PRE-PRODUCTION PCBA INSPECTION

Date: 26-10-2020
Revision: 1.0
Author: Tony Little
Product: Electric Skateboard
Company: Globe Brand

2.1.1 MAGNETIC CONNECTOR SENSE RESISTOR

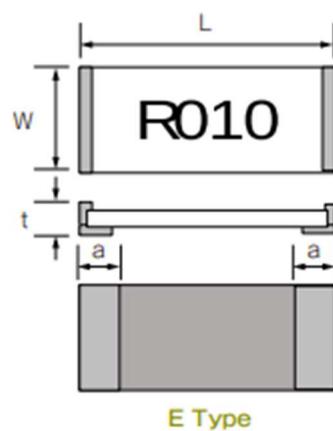
R50 Changed. Prior production required manual soldering of additional 10mohm in parallel. V3.6 to feature revised 5mohm requirement.

Resistor appearance consistent with brand, series and marking (for 5mohm) as expected for the E terminal type. Resistor not removed to verify, as difficult to measure and markings give confidence change was implemented.

2.1.2 BATTERY CHARGER VOLTAGE RANGE ADJUSTMENT

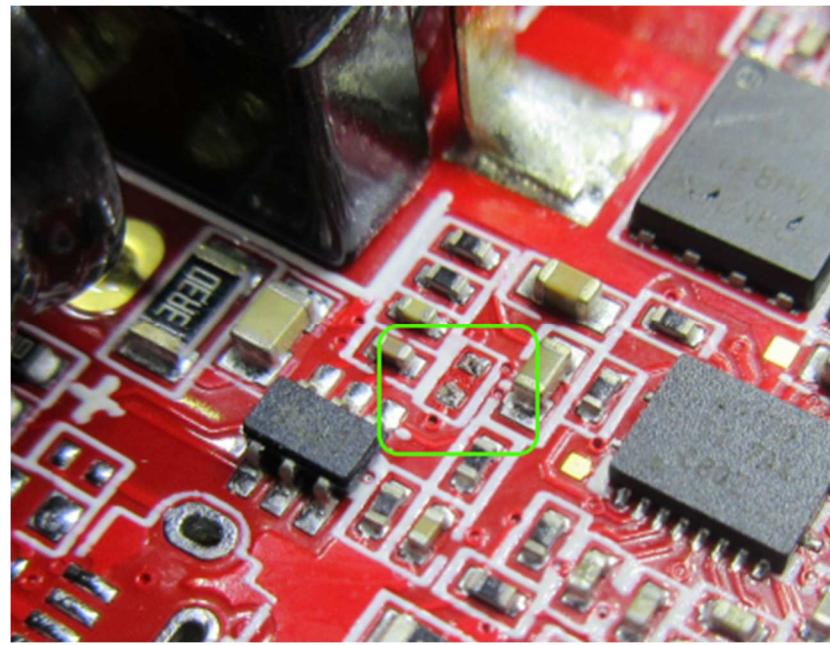
R26 47k → 45.3kohm

Removed part and measured 45.255kohm.

The BOM has an error. Manufacturer part is correct for 45.3k, however comment uses 43.5k (incorrect).

2.1.3 BATTERY CHARGER UNDERVOLTAGE LOCKOUT

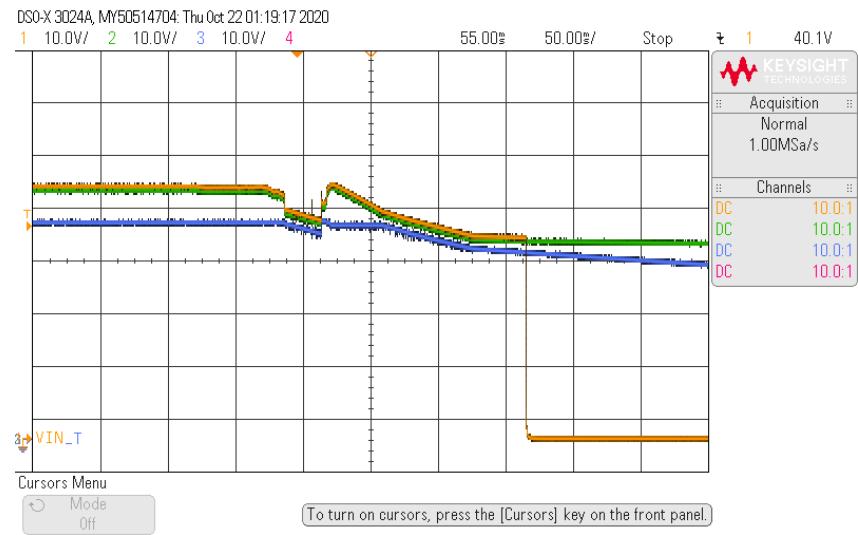
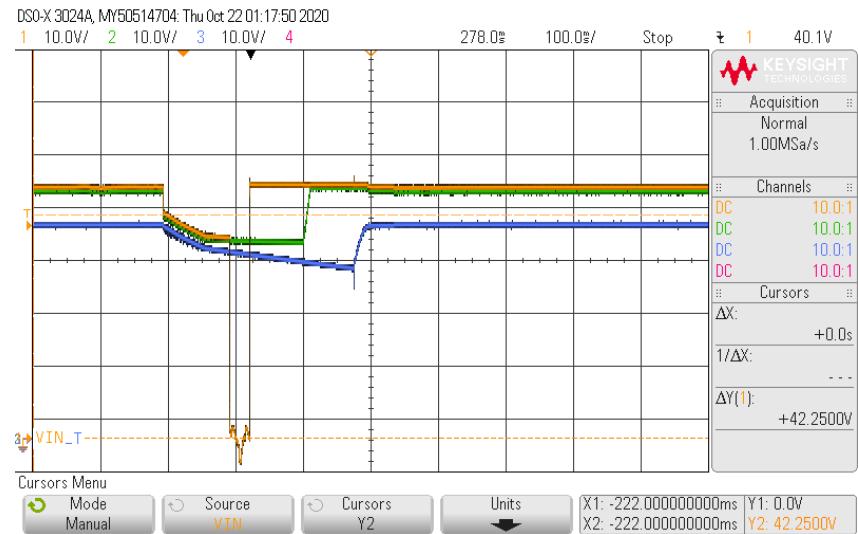
R177, R178, C59 added. Under voltage lockout for regulator.

Component placement moved. R168, D9, F20

Under voltage lockout performed as expected. Disturbance and disconnection.

2.1.4 BATTERY CHARGER REGULATOR SOLDERING

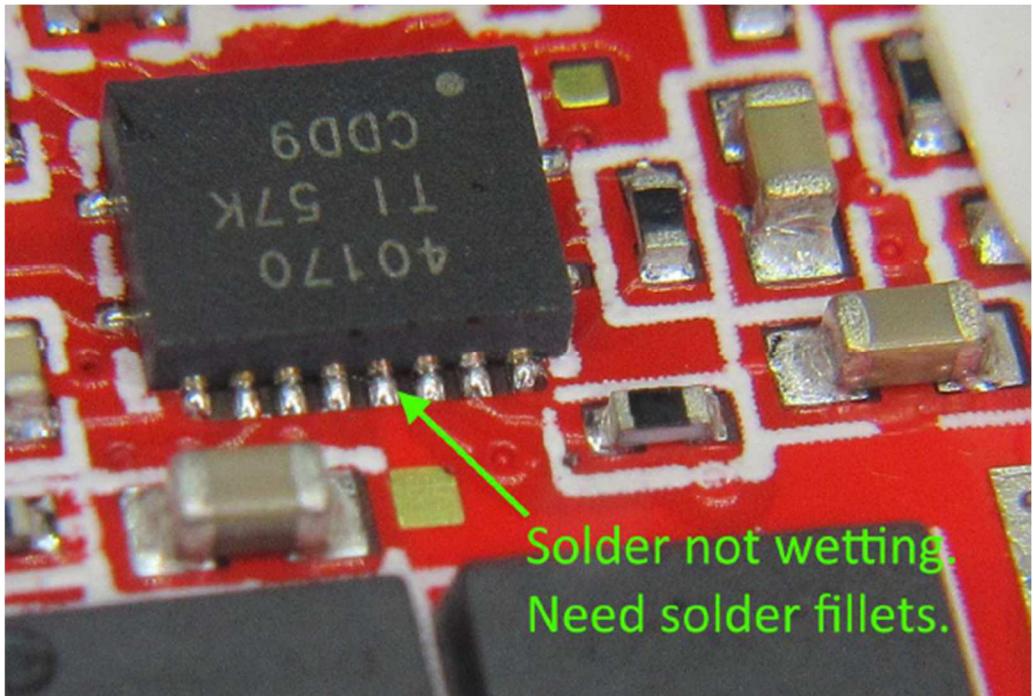
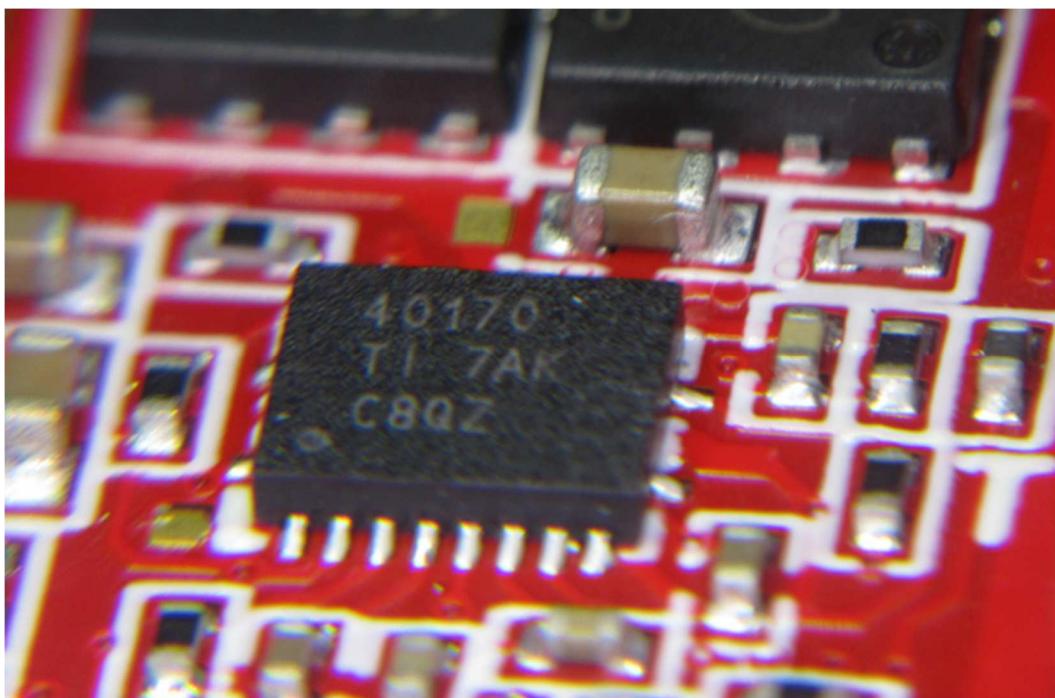
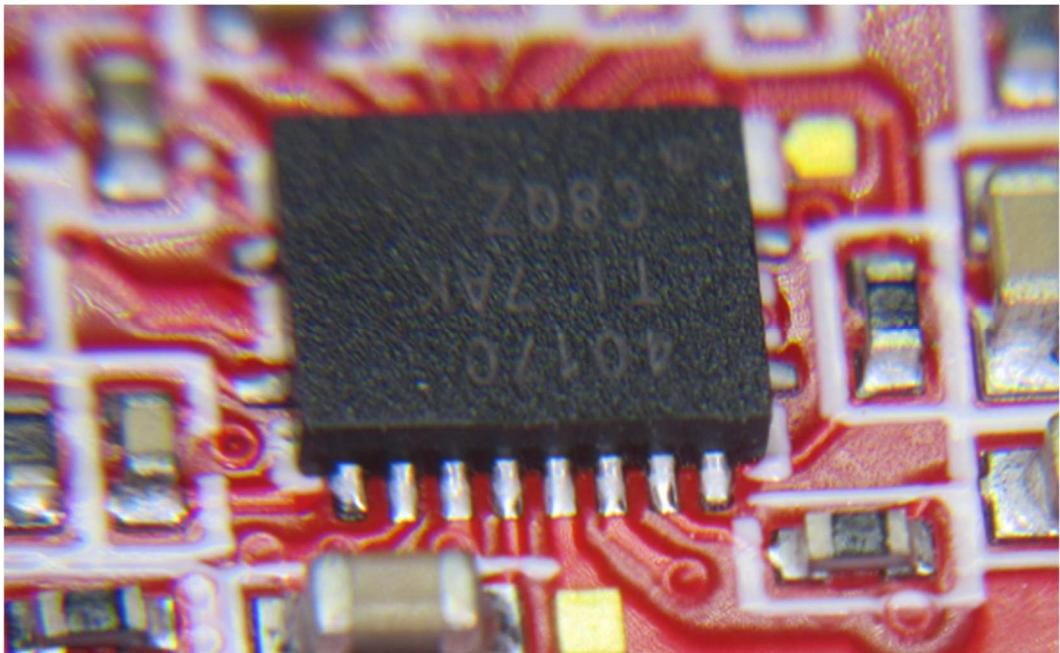
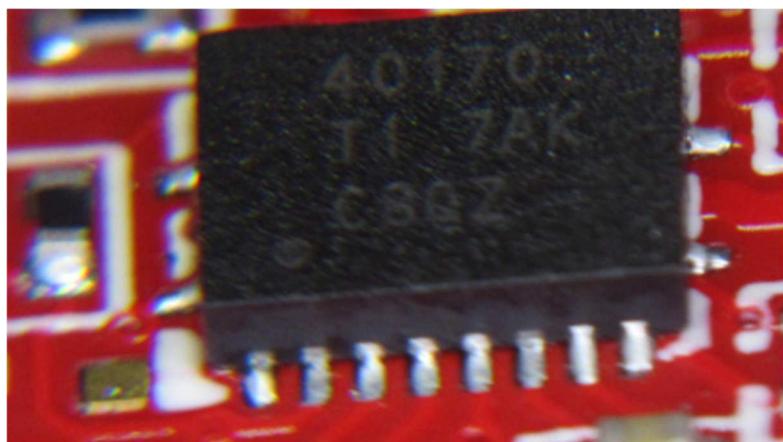
Previous concern has been the poor solder wetting on IC2, which may have contributed to battery charger failures. It is likely the parts have oxidized, resulting in poor solderability. Example below.

The worst example from the set of 5 is shown below. Possible indication of production variation.

Union applied addition flux prior to reflow, which has resulted in a significant improvement.

2.1.5 USB POWER / VSYS

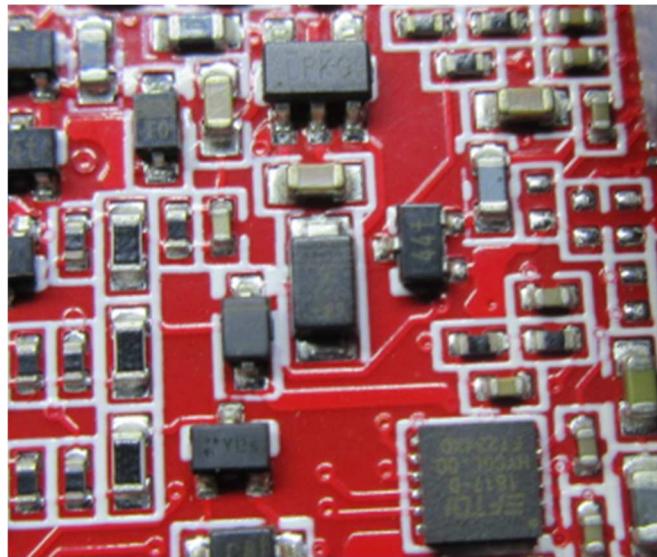
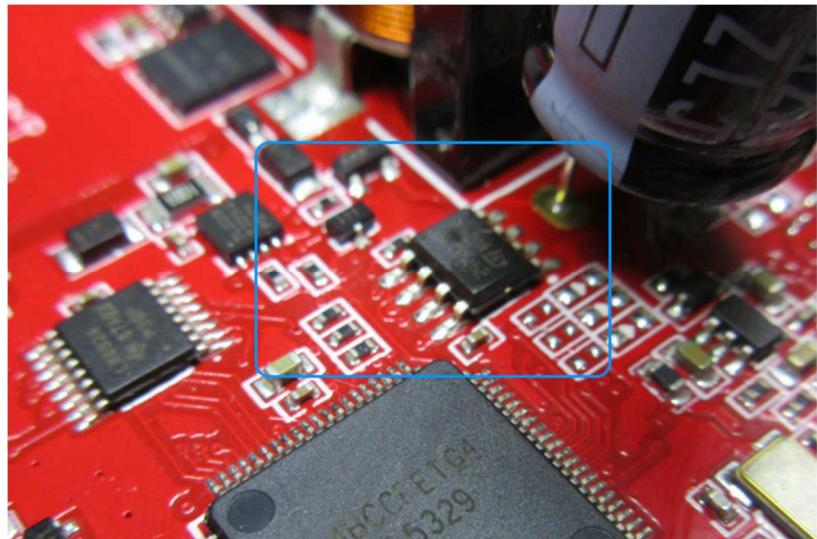
D44 moved, D49 added.

USB power connection does not generate previous interference with V_{Sys} level.

2.1.7 WIRING HOLE ADJUSTMENT

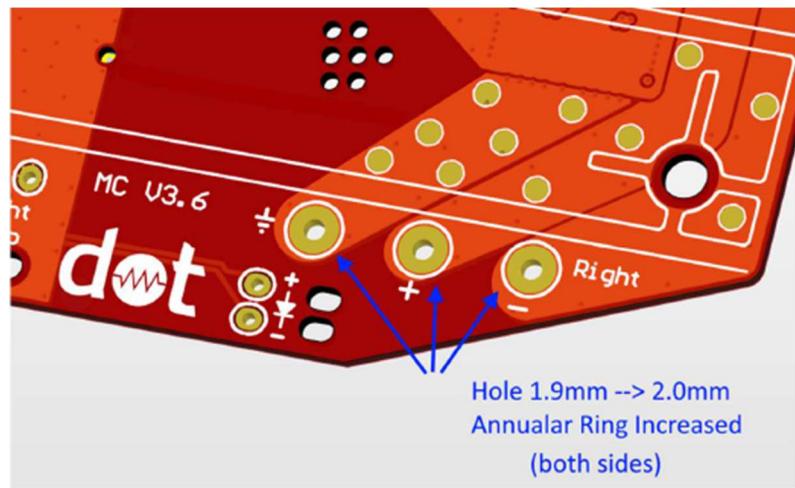
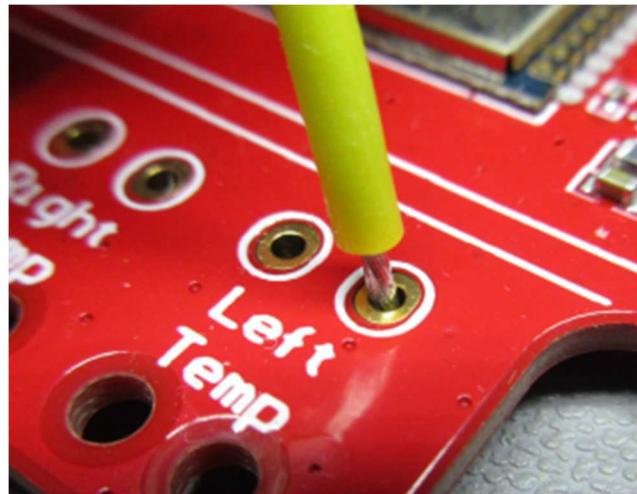
Motor wire pads increased from 1.9mm to 2.0mm. Pad size on solder side increased.

Wire fitment is considered loose, but acceptable.

The RTD wiring fits acceptably loose. The ground connection on L2 & L3 for RTD ground wire pads was removed to improve solderability.

2.1.8 USB CONNECTOR SOLDERING

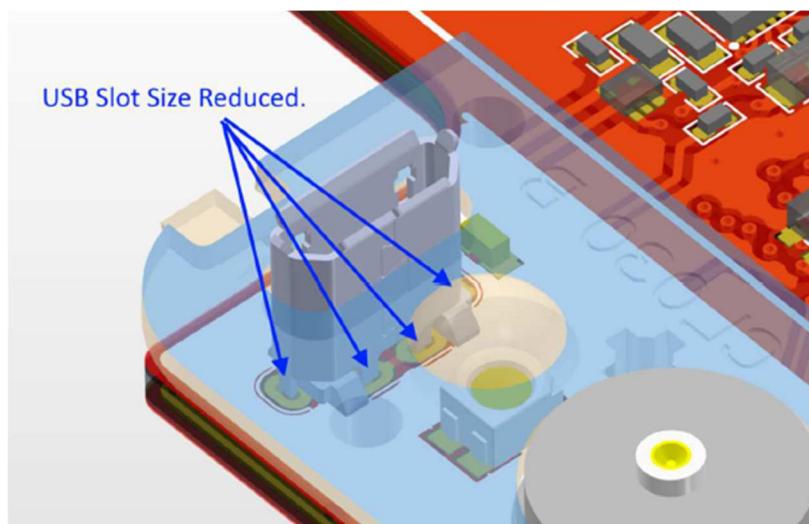
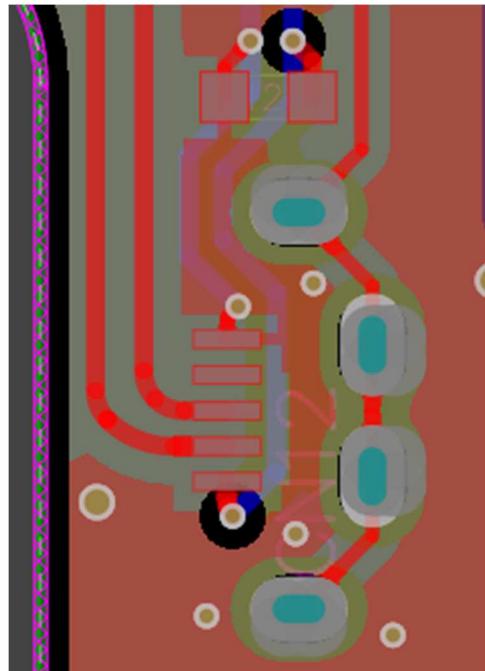
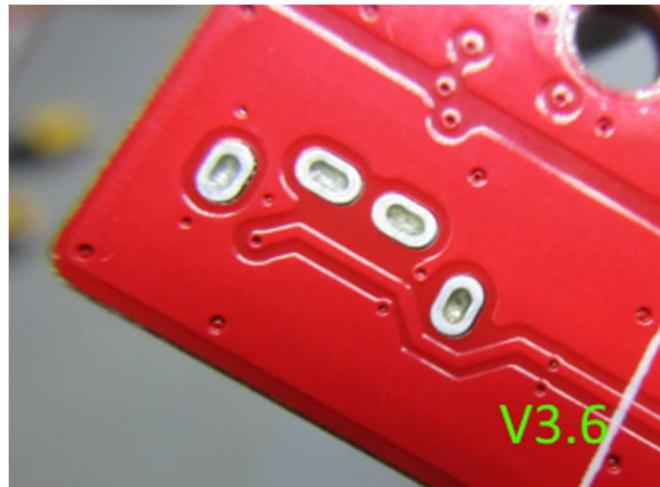
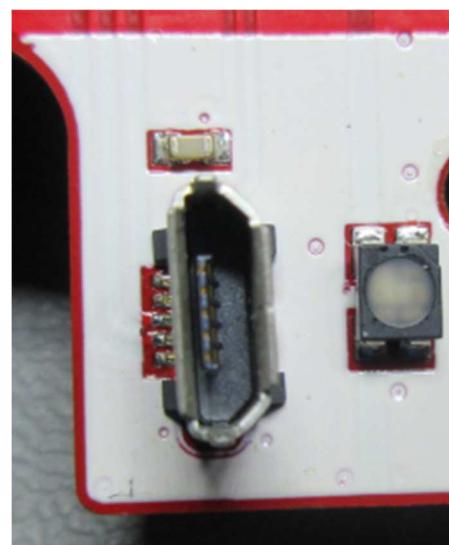
The same USB connector footprint update on the remote was applied to the MC. The changes were to improvement alignment and to increase solder fill.

The paste geometry update as shown below. Paste increased beyond mask perimeter for chassis pins.

The improvement in solder fill is quite noticeable. Below shows V3.5 in comparison to V3.6. This may both improve USB connector retention/strength as well as make Jesse happy.

All USB connectors are well aligned.

2.1.9 INDUCTOR L3 SOLDER MASK CHANGE

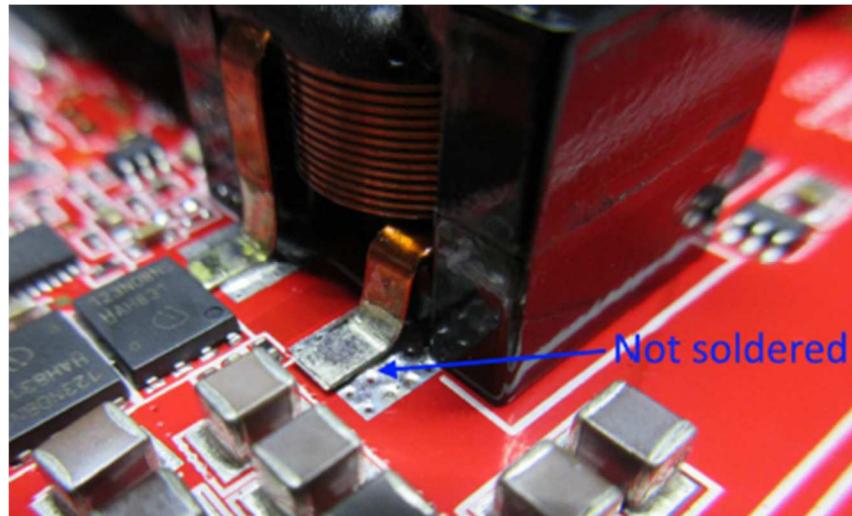
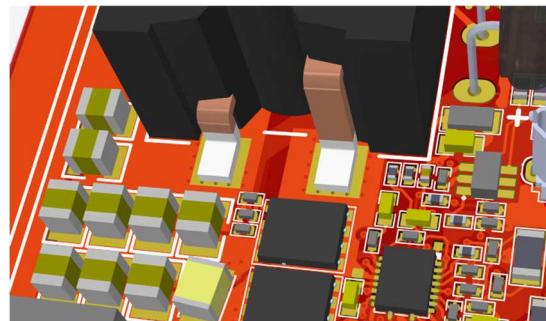
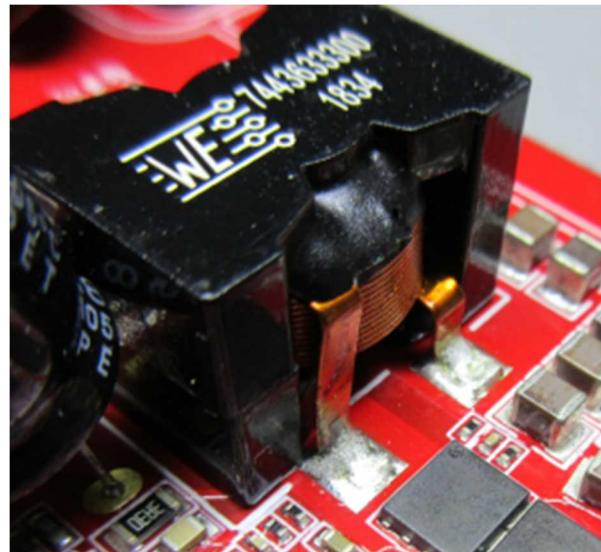
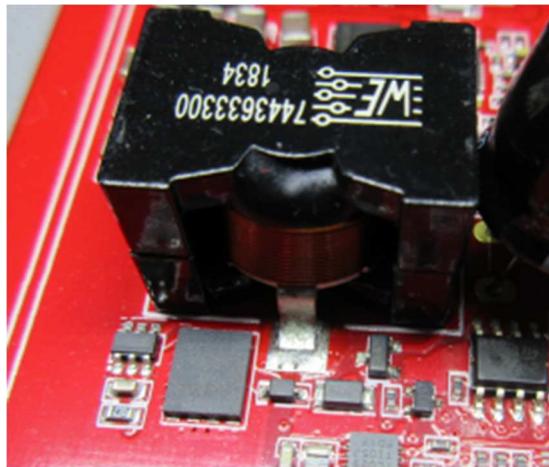
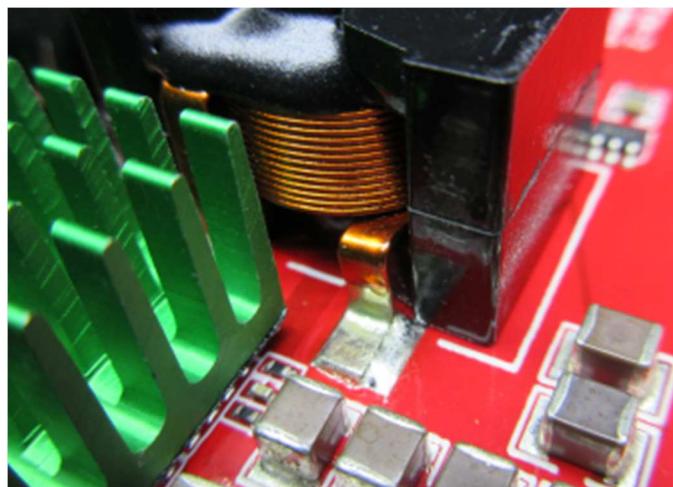
Several prior production faults were due to soldering issues with the large battery charger inductor. Both joint and inductor mis-alignment issues. Footprint used was as specified by the manufacturer.

Significant improvement in solder fillet/volume observed. Change most evident.

Worst case example below. Mis-alignment considered minor.

The PCB footprint design was updated with a reduced mask area, while maintaining paste beyond mask perimeter.

3.2 WIRE SOLDERING

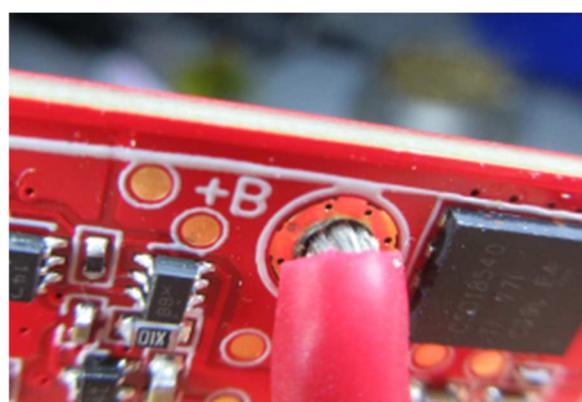
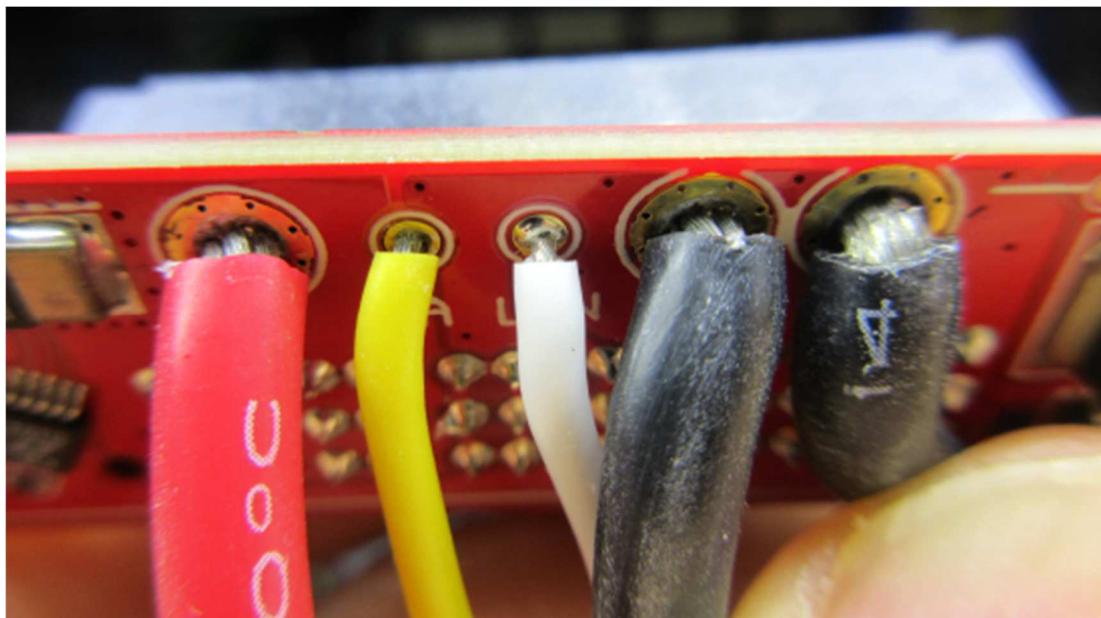
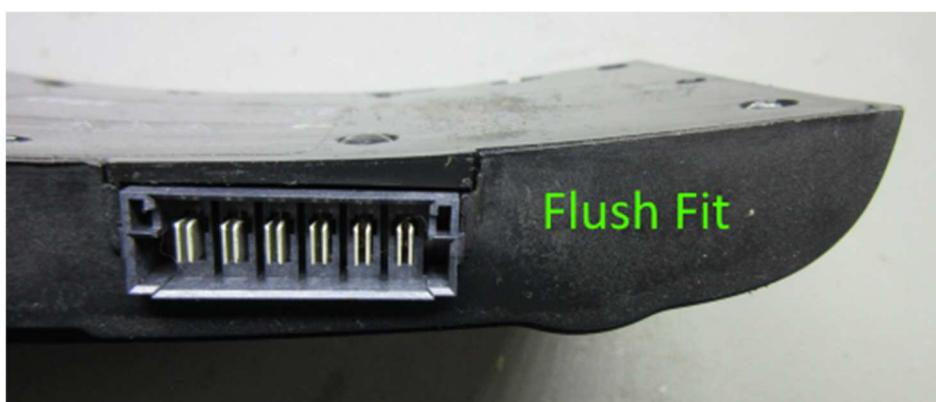
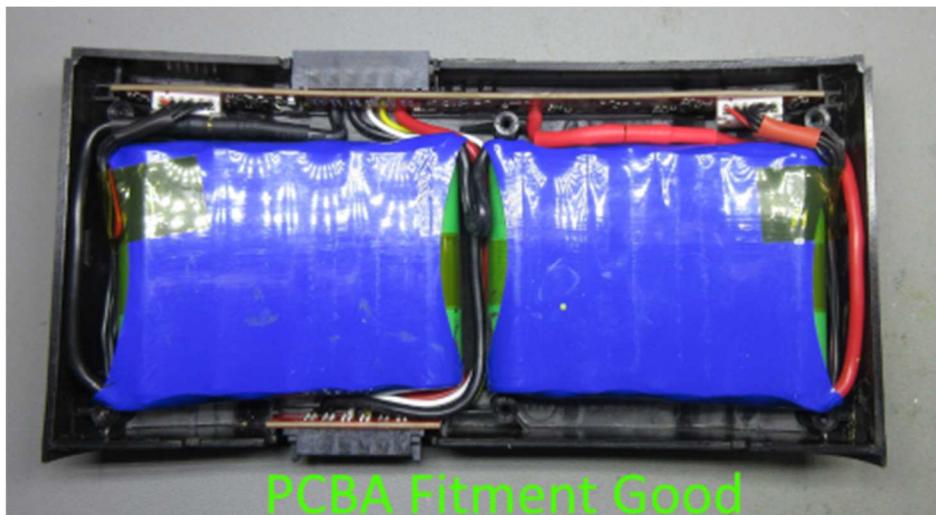
The wire soldering has historically not been at the desired level, however has never been a functional issue. The wiring holes were increased slightly at Unions request to improve the through hole fill and filleting on the opposite solder side. The land area was also increased slightly.

The through hole is getting sufficient fill for the functional requirement. Operator soldering speed is likely pushed too fast. Hot air pre-heating would also be preferable.

Although still not at the desired level, there is no historical functional issue to pursue further changes.
